NORTH SYDNEY COUNCIL REPORTS

ADDRESS/WARD: 1 Bank Lane, North Sydney

APPLICATION NO: RD7/21 - Section 8.2 Review of determination (DA18/21)

PROPOSAL: Review of determination of application for the demolition of the

Figure 10: Non-complying setbacks highlighted in red

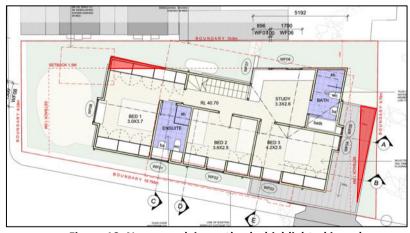
Elevation	Proposed	Control	Comply
N Elevation			
GL	900m	900mm	Yes
FF	900m	1.5m	No
E Elev			
GL	Carport = 0m	900mm	No
FF	Dwelling = 1.6m	1.5m	Yes

The non-compliance is limited to a non-habitable space being "built-in" storage – refer to **Figure 10** above. This element adjoins the Heritage Item at No 3 Ancrum Street and although the non-compliance in itself does not result in overlooking or overshadowing, the bulk and scale of the two storey structure is not supported. The non-compliant setback adds to the massing which overwhelms and dominates the existing single storey heritage item to the north (refer to **Figure 11**), and not allowing appropriate separation between buildings failing to satisfy **P2 and objectives O2 and O3.**

WESTERN (ANCRUM STREET) ELEVATION

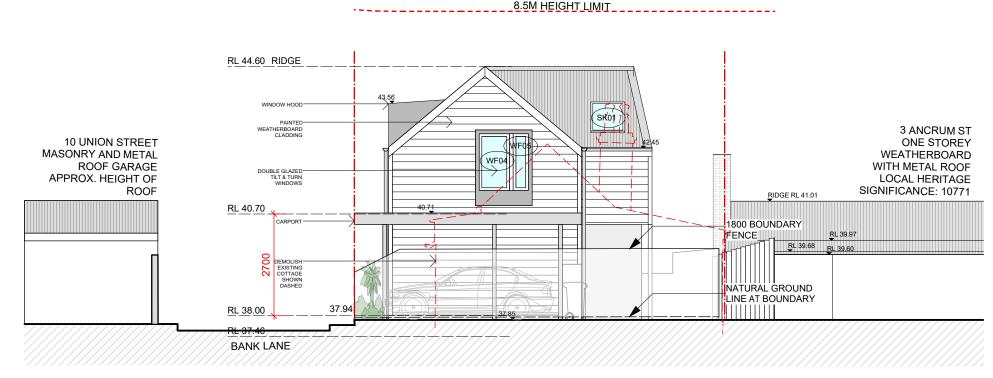
The proposed development results in a two storeys built form, with the addition not being contained wholly within the roof space allowing for clear wall planes / massing. As such the proposal is not consistent with the established streetscape. The resulting built form is significantly larger than the existing characteristic dwellings with a scale and massing which is considered to dominate the surrounding spaces.
